Supplement to EMC Test Report for Motorola portable cellular phone (FCC ID IHDT56JT1)

Summary of FCC request for additional information

GSM 850 Occupied Bandwidth

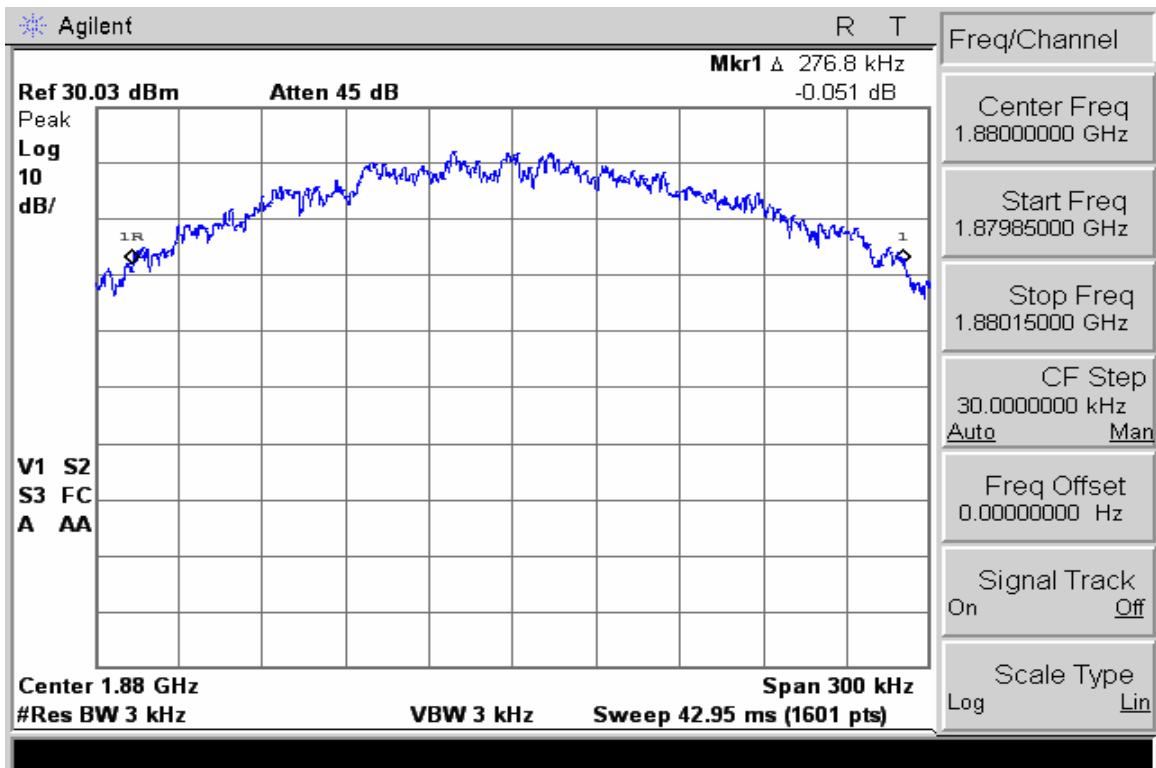
6. For Exhibit 6, 21653-1, GSM 1900 EDGE Bandwidth measurement right marker should be placed further to the right most peak, to capture the entire bandwidth. Please update marker placement and bandwidth value.

6. While reviewing the report, it was discovered that the GSM 850 and GSM 1900 bandwidth plots had the same issue. The new plots for GSM 850, GSM 1900 and EDGE 1900 are attached below.
